RS-03-223

Dresden Nuclear Power Station, Units 2 and 3
Facility Operating License Nos. DPR-19 and DPR-25
NRC Docket No. 50-237 and 50-249

Subject: Additional Information for the Review of the License Renewal Applications
for Dresden Nuclear Power Station, Units 2 and 3 and Quad Cities
Nuclear Power Station, Units 1 and 2

**Response to Request for Additional Information – Section 3.1 and Associated Aging
Management Programs**

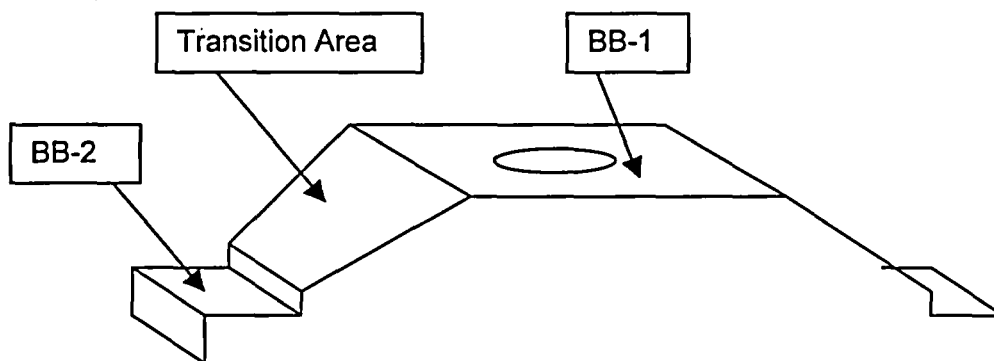
As specified by the Response to RAI B.1.9 (d), the applicant provides experience of the jet pump failure by referencing Quad Cities Licensee Event Report LER 1-02-001. The LER states that although Quad Cities Nuclear Power Station implemented the requirements of BWRVIP-41, including periodic inspections of the required areas of the jet pump hold down beams, the transitions areas of the beam was not required to be inspected and the crack was not identified prior to failure. However, Table 3.3-1 of BWRVIP-41 provides inspection guidelines for location BB-2 (Beam Transition Arm Region) of the jet pump. Explain this contradiction and confirm that the inspections required by BWRVIP-41 will be performed, including the beam transition area of the jet pump.

The statement is not a contradiction. Inspections recommended in BWRVIP-41 are divided into both baseline and re-inspection recommendations based on an inspection cycle of six years. Baseline inspection required UT or other NDE technique of all beams during the next inspection cycle. Fifty percent of the inspections were to be performed in the next refueling outage. Re-inspection requirements are 50% per inspection cycle for the first 20 years of service and 100% per inspection cycle beyond 20 years of service. Both Dresden and Quad Cities have performed 100 percent UT inspections of the BB-1 and BB-2 each refueling outage since 1995, which exceeds BWRVIP-41 recommendations.

However, the cracking occurred in the transition area, located between BB-1 (the area surrounding the bolt hole) and BB-2 (the machined radius or ear). The transition area is a low stress location, outside the area of interest specified by the BWRVIP-41. (See below sketch.)

As part of the corrective actions from the LER root cause investigation, Exelon has requested the BWRVIP committee to provide further evaluations of the adequacy of the examinations performed on the hold down beams. Exelon will continue to perform the inspections required by BWRVIP-41 (BB-1 and BB-2) and will incorporate the additional changes in inspection methodology when incorporated into BWRVIP-41.
